EARLY DESIGN GUIDANCE OF THE EAST DESIGN REVIEW BOARD

Project Number: 3012437

Address: 1620 12th Ave

Date of Meeting: Wednesday, October 19, 2011

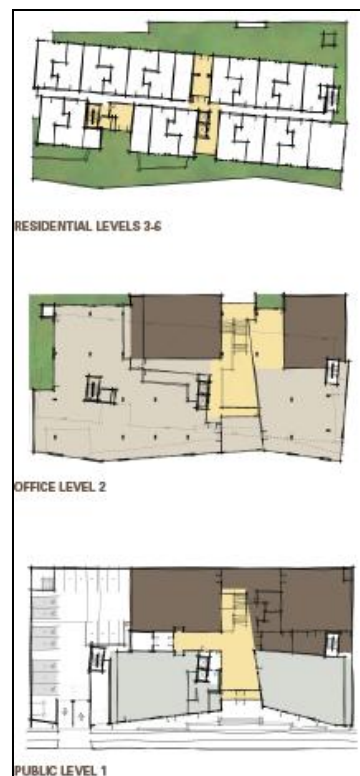
- Encouraged the preferred scheme because it offers more interesting and unique architectural forms. Argued that creating a civic building with an unusual design has precedent in the neighborhood.

At the Early Design Guidance Meeting, the Board encouraged the three building forms of the preferred option to relate to each other and be perceived a part of one design concept. The Board enthusiastically supported the diagonal configuration of the upper levels as a sensitive solution to the zone edges.

At the Early Design Guidance Meeting, the preferred design concept was acknowledged by the Board as both innovative and exciting and should be further developed. The Board did, however, offer several remarks regarding the architectural concept and its application throughout the site.

While the proposed cantilever of the second story office level gives a dramatic form to the building, the Board expressed concern that the depth of this projection is critical and should not overshadow the retail uses or entry plaza space. As shown in the preferred option, the Board agreed that the overhang was too oppressive. The opportunities to integrate signage at this overhang should be explored, as well as other forms of overhead weather protection.

The upper level residential levels should not be relegated to conventional design above a dramatic base; instead the dramatic base should inform the upper floors. The three part *parti* of the building forms (and corresponding uses) may be on three different planes, but they should align or knit together at some junction. The Board also suggested that the staggered horizontal planes of the building should meet at one vertical plane at the southwestern corner of the building.
